REGIONAL REVIEW NOTICE

ARC REVIEW CODE: R1604252

Name of Proposal: 905 Memorial Drive

DRI #2557 – 905 Memorial Drive

ARC SITE PLAN

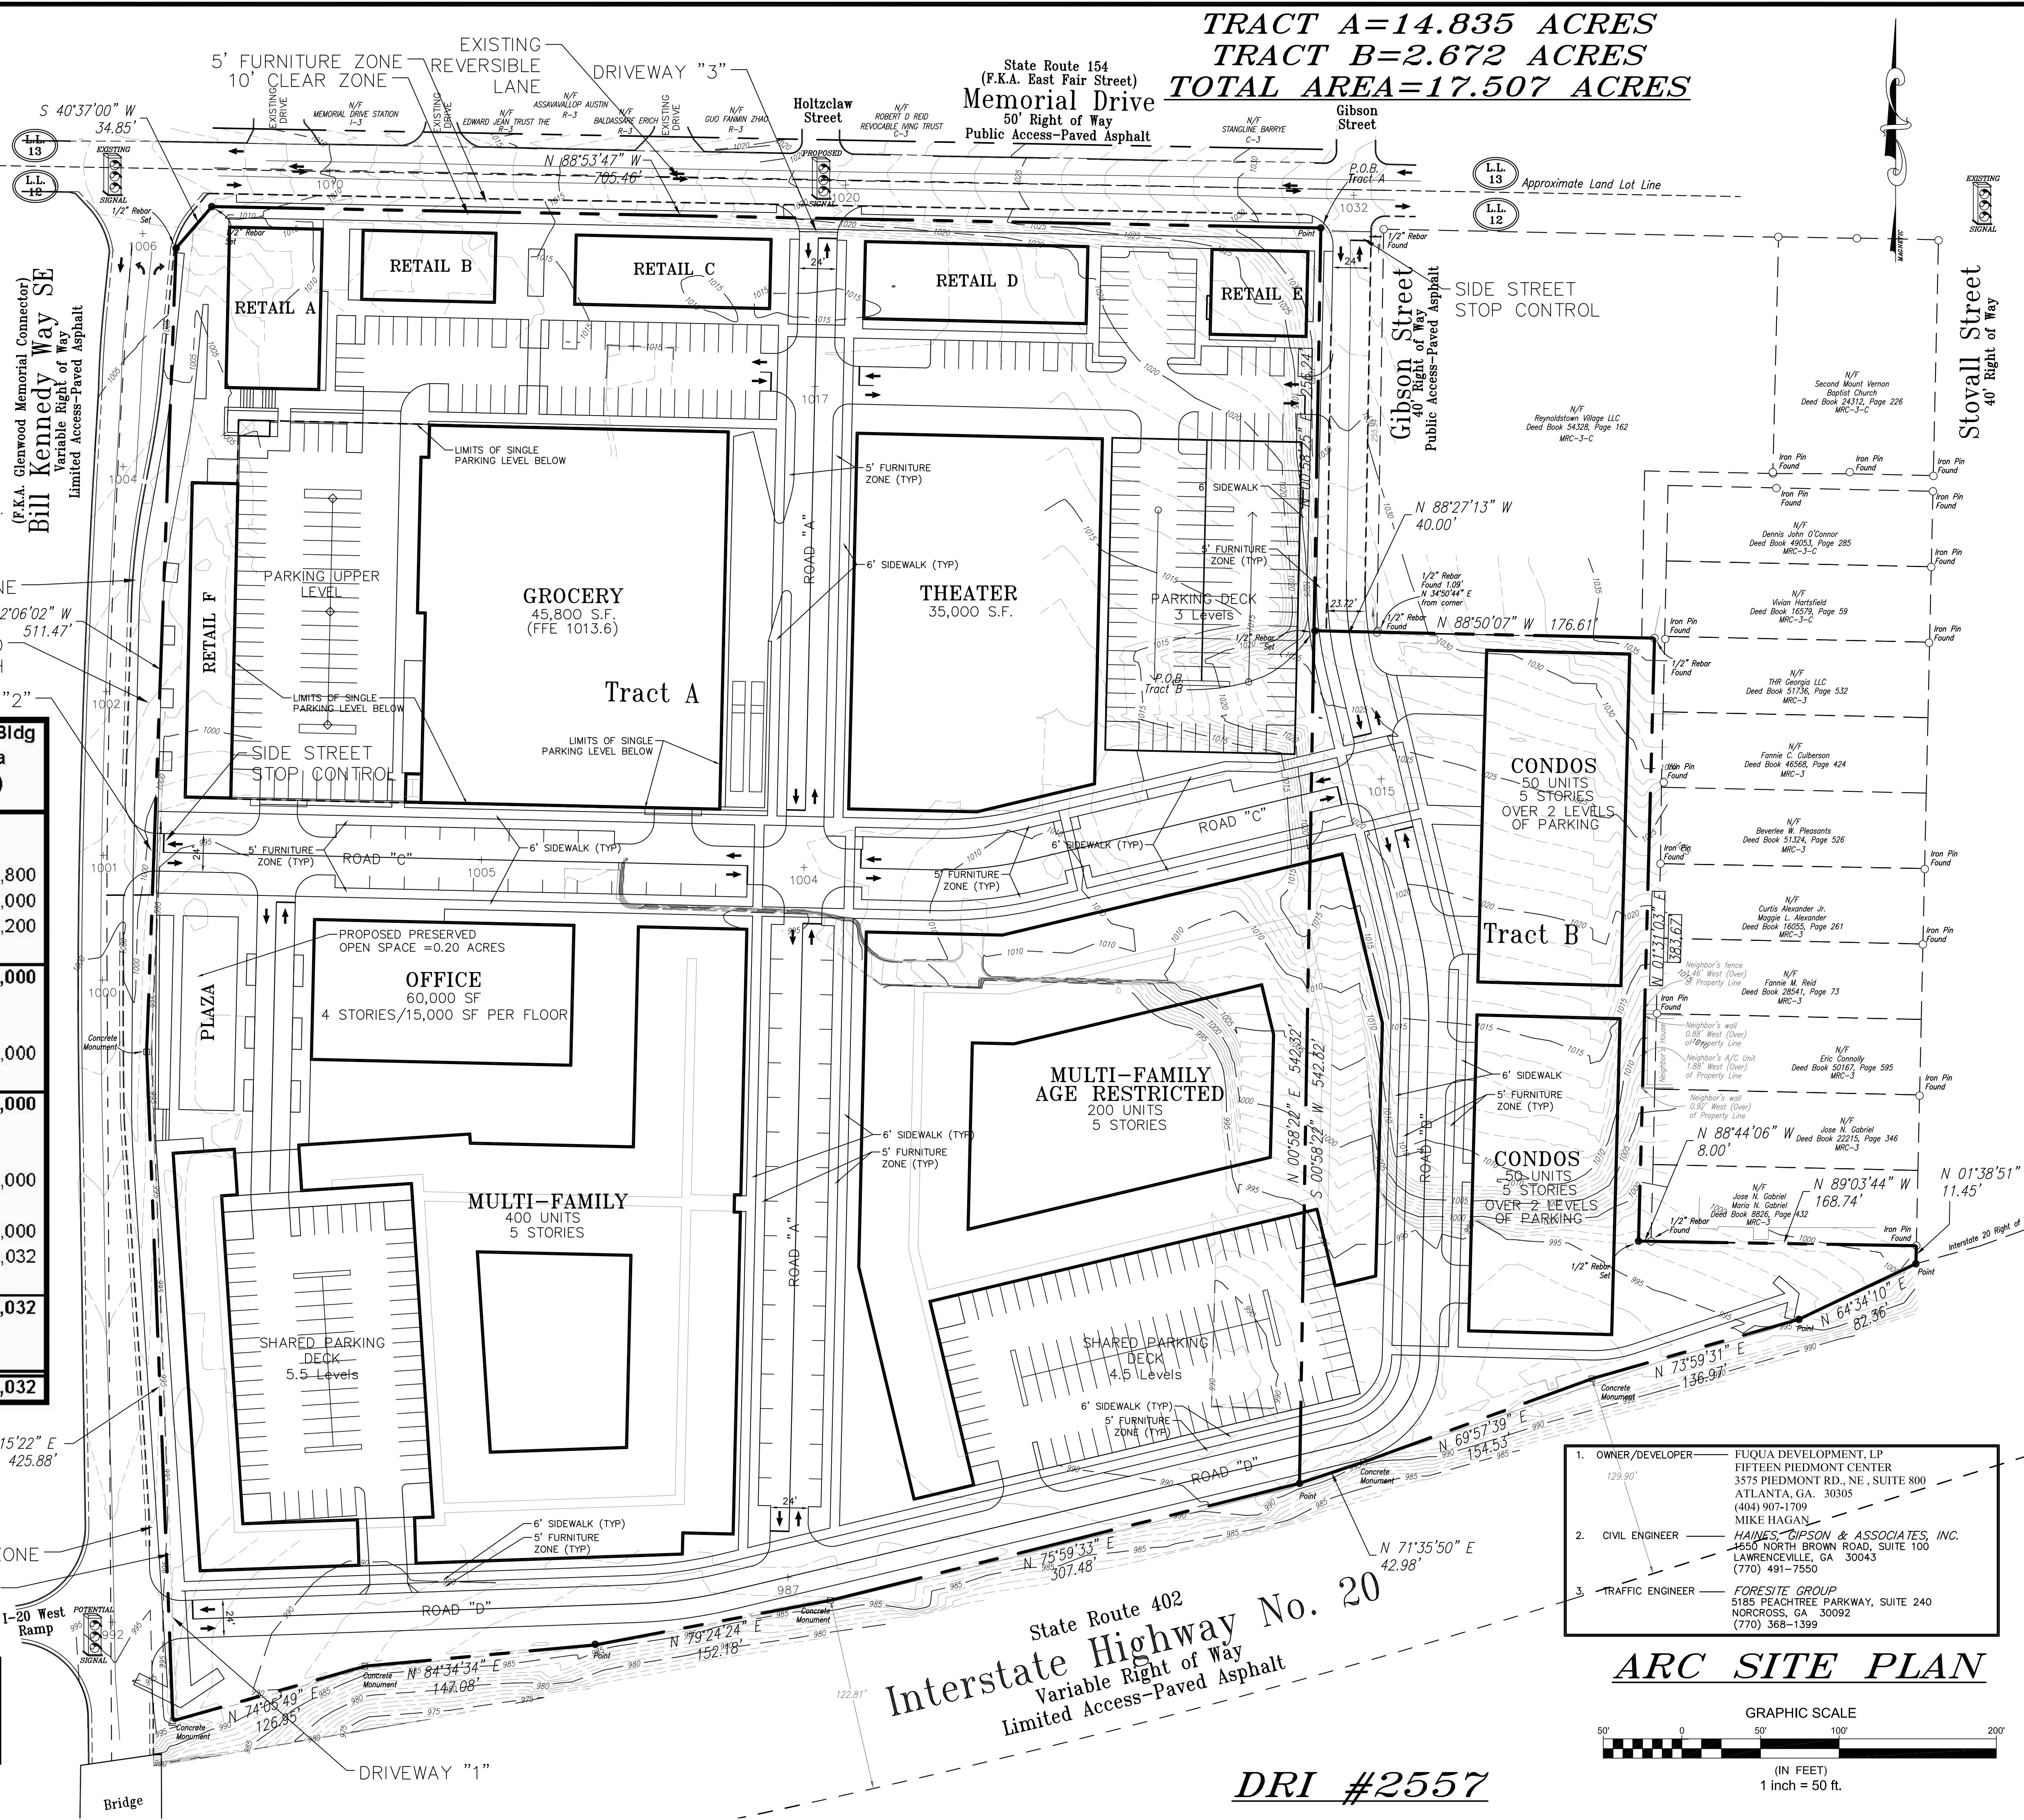
The current development plan proposes 1,872 parking spaces, 644 more than required by City code. In keeping with the goals of ARC's LCI program, the developer and City staff should work together to consider reducing the amount of parking on the site to reinforce and encourage the use of alternative transportation modes such as transit, bicycling and walking. Use of these modes is already present in the area, and parking reductions can be accomplished, at least in part, through additional shared parking strategies (shared parking is already contemplated in the development plan) and tools such as a Transportation Management Plan. Parking on site appears to be effectively screened.

Parking is significantly higher than required by the City – 50-70% depending on use – and should be reevaluated given this location's urban location, proximity to transit and regional alternative transportation routes, and adjacent neighborhood character;

Bike lanes along Glenwood Avenue should be expanded northwards or connected to Atlanta Beltline Trail section to improve bicycle access to surrounding neighborhoods;

Add bike lanes to Gibson Street;

Bike parking provided along Bill Kennedy Way and Memorial Drive, consistent with City policy or industry best practices;

Driveways along both sides of development should be consolidated to as few as necessary (four is probably too many, need to review data in more detail).
